MODEL	Sorter for F21	VOLT/Hz	DATE OF MODIFICATION	SERIAL NO
MODIFIED ARTICLE	Parts Catalog			
REASON OF MODIFICATION	Parts Catalog Correction

MODEL	Sorter for F21	VOLT/Hz	DATE OF MODIFICATION	SERIAL NO.
MODIFIED ARTICLE	Transport Belt Roller			
REASON OF MODIFICATION	To prevent the transport belts from moving out of the transport rollers

Model	Sorter for F21 and F22	Volt/Hz	Date of Modification	Serial Number
Modified Article	Magnet Catch			
Reason for Modification	Parts standardization

2. TRANSPORT 1 (A029) (Page 6)

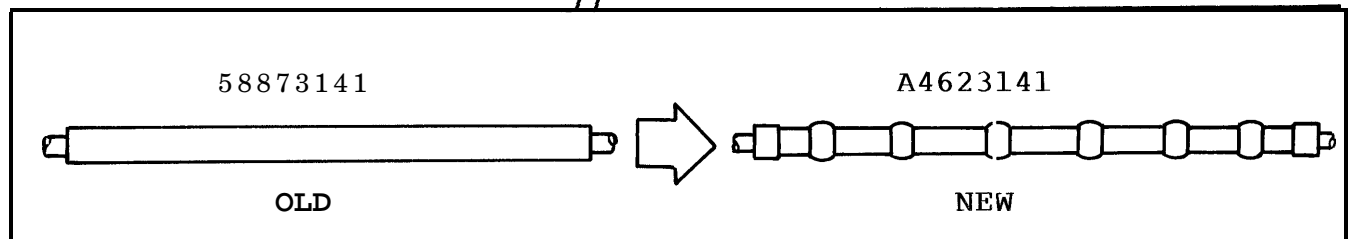
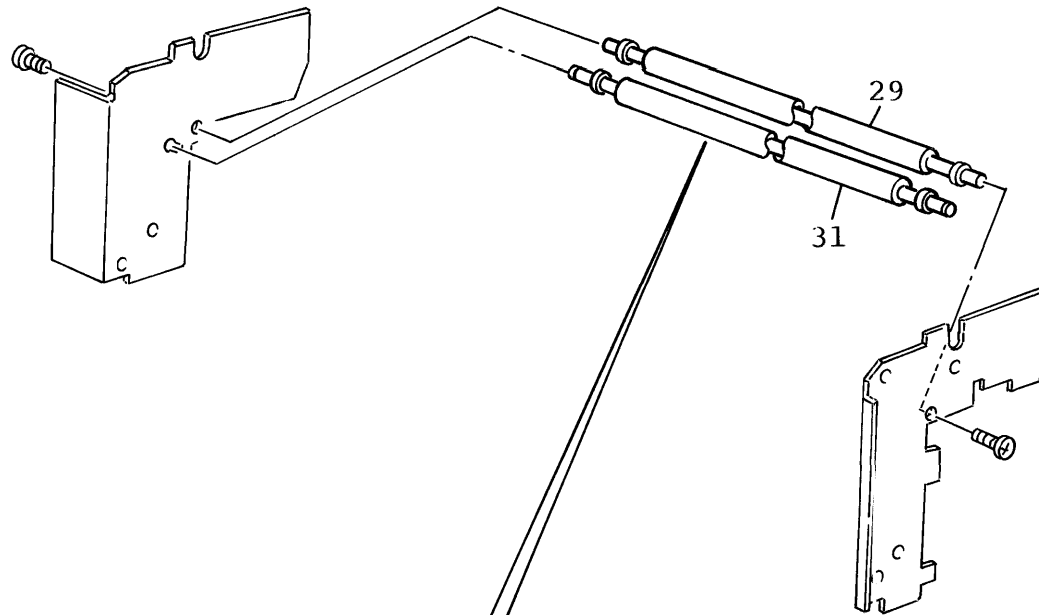
DRAW. No.	OLD PARTSNO.	NEW PARTS NO.	DESCRIPTION	A.B.C	Q'TY USED OLD→NEW	INTER-CHANGE-ABILITY	PART NEEDED FOR REPLACEMENT BY NEW PART		PART CATALOG	
				RANK			PART NO.	DESCRIPTION	INDEX NO.	PAGE
	58873141		Transport Belt Roller		2 - 1				29	7
		A4623141	Transport Belt Roller		0 - 1	X / O			*31	7
									*:New Index

To prevent the transport belts from moving out of their correct positions on the transport rollers, one of the transport belt rollers has been changed to the rounded type as shown in the illustration. As a result, when the transport belts start meandering, the new roller returns them to their correct positions.
